Sirsi Marina Overland Flow Study

Prepared for Essex Develop

October 2023
Project Number S22042

6. Response to Council comments

Figure 9 Proposed Council Pipe Diversion

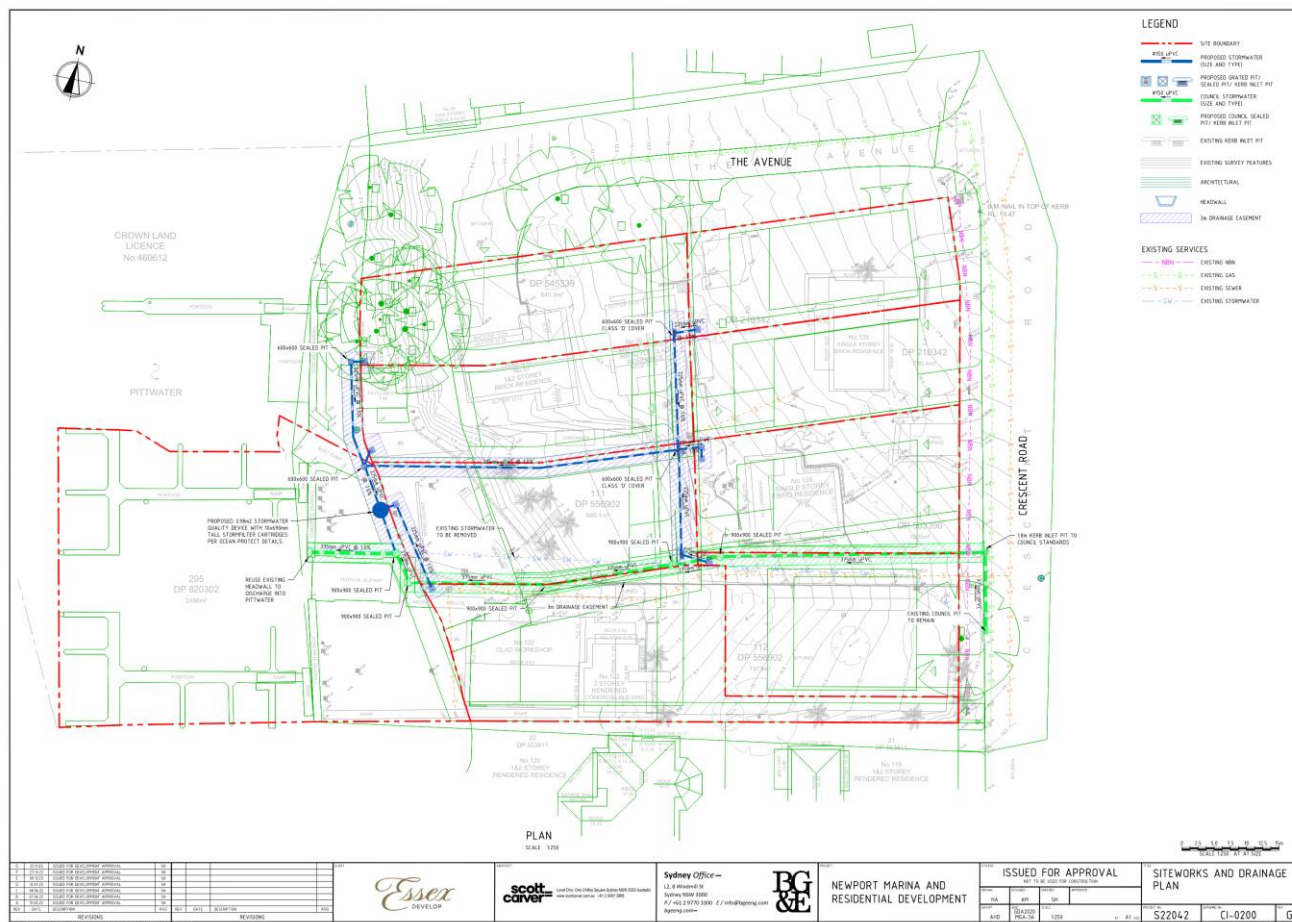
- It is noted that the design engineers BG&E propose to re divert Councils existing 375mm RCP stormwater (SW) line which runs through the current site to the southern boundary with a 3m wide stormwater drainage easement over the re diverted drainage line. This proposal is supported by Councils stormwater assets team.

- The re diverted Council stormwater line running through the site is to be upgraded to have a minimum hydraulic capacity of 5/100 AEP. Flows in excess of this event are to be controlled via an above overland flow path to the 1 /100 AEP.

The proposed development aims to reroute an existing council stormwater 375mm diameter pipe around the site and eventually discharge through the existing headwall at Pittwater Waterway to the site's west. The site lacks any natural water courses, and the existing seawall is expected to remain in good, non-degraded condition for the purpose of re-use. Refer figure 9 for the proposed Council pipe diversion adjacent to the northern boundary of the proposed lot 4. A new kerb inlet pit is proposed north of the existing kerb pit along Crescent Road, which will form part of the pipe diversion network.

The DRAINS modelling shown in section 5.3 indicates that the current pipe division is adequate to meet council's requirements. The modelling also showed that the pipe sizing, being council's minimum size, would also cater for the 1% AEP event being 50% blocked.

Figure 10 Close up of the Proposed Overland Flow path and Stormwater Diversion

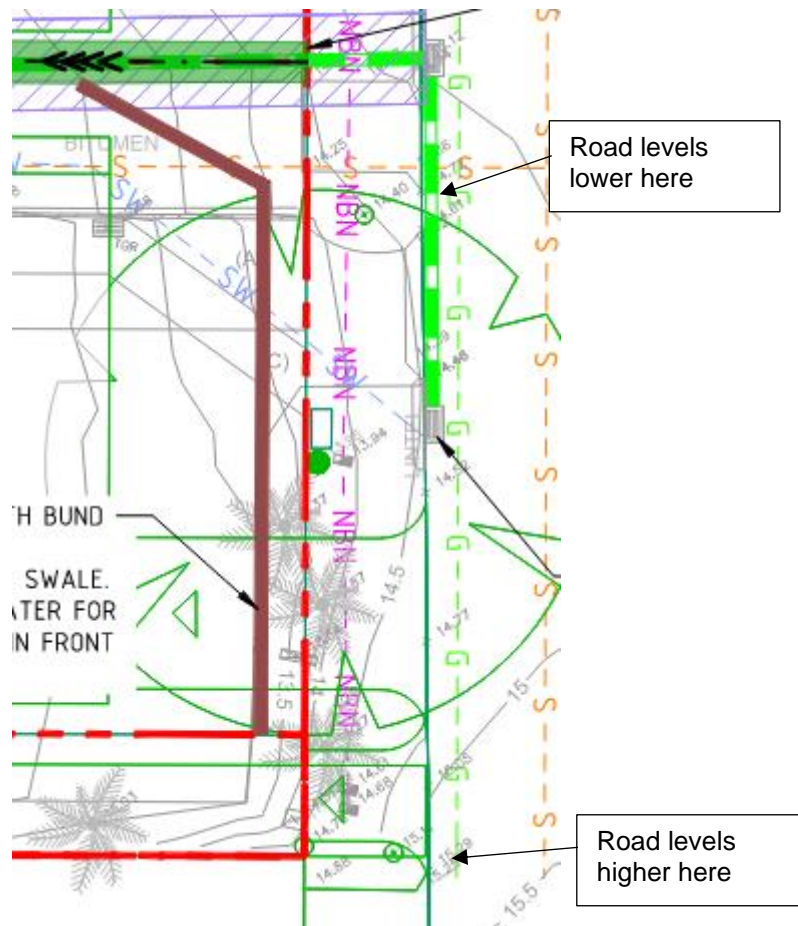
- The current proposed location of the overland flow swale is not acceptable as the overland flow path needs to be aligned with the sag pit Crescent road ie the lowest point . Any overland flow originating from this location cannot physical enter the proposed swale given its separation from the current sag point. Any over land flow path should be aligned from the current sag point in the Crescent Road and follow the alignment of the proposed re diverted Council SW line to the discharge point.

| Council Comment | BG&E Reply |
|---|---|
| <p>1. The site is affected by overland stormwater flows in larger storm events predominately along the line the of the existing Council 375mm Concrete stormwater line which runs from the sag point in Crescent Road to the existing seawall . An overland stormwater flow study is to be prepared by a NER/RPENG qualified civil engineer to determine the extent of the overland flow path and impacts on the development including the proposed construction of dwellings. The study is to be prepared by a suitable computer hydrological/hydraulic model. Councils preferred model is DRAINS. The overland flow cross-sections are to be determined by the HEC Ras programme or similar.</p> <p>a. It is noted that the design engineers BG&E propose to re divert Councils existing 375mm RCP stormwater (SW) line which runs through the current site to the southern boundary with a 3m wide stormwater drainage easement over the re diverted drainage line. This proposal is supported by Councils stormwater assets team.</p> <p>b. The current proposed location of the overland flow swale is not acceptable as the overland flow path needs to be aligned with the sag pit Crescent road ie the lowest point . Any overland flow originating from this location cannot physical enter the proposed swale given its separation from the current sag point. Any over land flow path should be aligned from the current sag point in the Crescent Road and follow the alignment of the proposed re diverted Council SW line to the discharge point.</p> | <p>1.a. BG&E accepts that council accepts the location of the stormwater pipe diversion and as shown in this report meets council's standards.</p> <p>1.b. The location of the overland flow path is the best location on the site due to the following discussed in this report:</p> <ul style="list-style-type: none"> • Location due to low point on site and inline with where the existing overland flow path is. <ul style="list-style-type: none"> ○ Moving the overland flow to the same location as the stormwater pipe diversion will force stormwater uphill and cause a large amount of ponding in the roadway • Can achieve a safe flow route <ul style="list-style-type: none"> ○ No Major structures in the flow path ○ No Pedestrian access ○ No Vehicle access ○ No impact on the future driveway • The overland flow is proposed to flow by a bund into the proposed swales in the temporary case and in the premiant case can be a wall or bund to control the direction of flow. <p>Council's request that the overland flow and stormwater diversion align does not work for this site due to the existing road levels. Refer to section 4.4 of this report.</p> |

To manage the overland flow, a proposed grassed swales along the boundaries of the subdivision lots 3-4 & 5-6. The current route is proposed as the existing site falls in this direction from the council sag pit, as shown in the survey. This also does not clash with any of the proposed driveways in future housing developments. A bund is to be installed as part of the subdivision works until the property is developed, at which time the bund needs to be made permanent, or a wall to direct the stormwater is to be installed. This is in line with the location for the existing start of the overland flow path and will result in the smallest impact no any ponding in the roadway. See Figure 10 for the proposed layout on top of the existing survey.

If the overland flow path were to be placed in the same location as the proposed stormwater pipe, this would require the stormwater to pond to a level of RL14.7, which is more than 100mm higher than the existing and proposed overland flow route.

The Council's Water Management for Development Policy states that the width of any easement for overland flow is controlled by the minimum practical width necessary for standard machinery to carry out reconstruction of the public drainage system.

Figure 15 DRAINS Model – 1% AEP Overland Flow Result

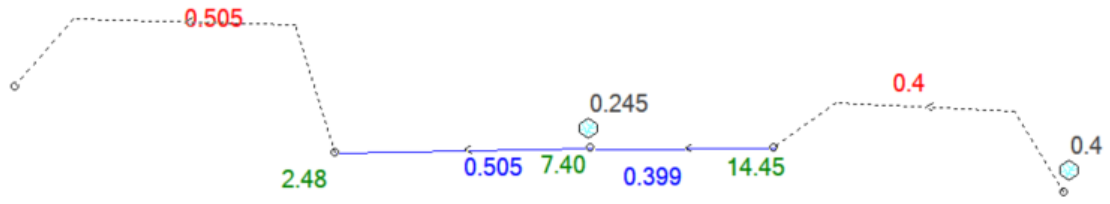
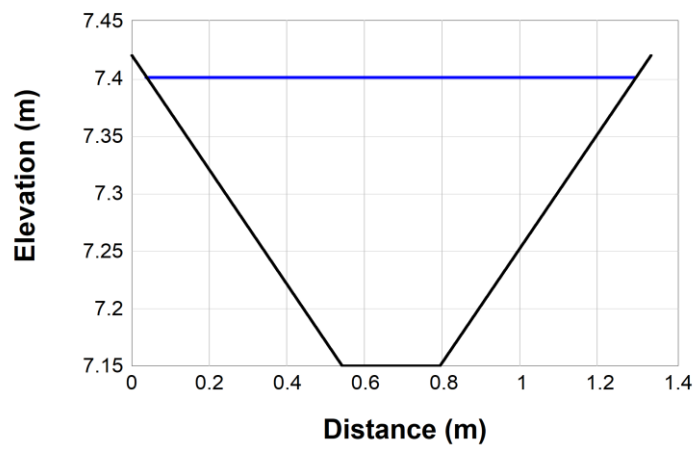
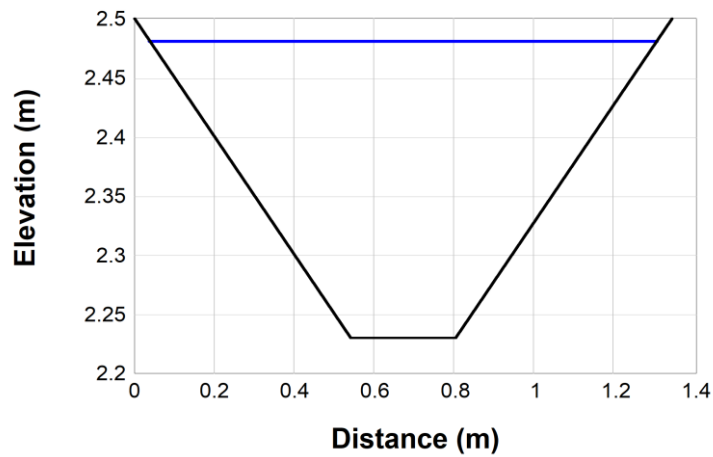
- The overland flow path is to be contained with a widened 3m easement from the sag point in Crescent Road to the outlet.
 - The study is to also review velocity depth ratio in relation to pedestrian safety.

The overland flow can be contained within 1.36m wide and 0.26m deep swales running along the boundary of lots 3-4 & 5-6. The hazard classifications are shown in Table 2 below based on Figure 6 from earlier in this report.

The hazard rating for the swale through the size of H4, which, as defined in table 1, is "Unsafe for vehicles and people. All buildings vulnerable to structural damage. Some less robust buildings subject to failure." The location of the swale results in only property fences being in this area. This is not an access path for pedestrians or vehicles. It's located out of the way of property and driveway access.
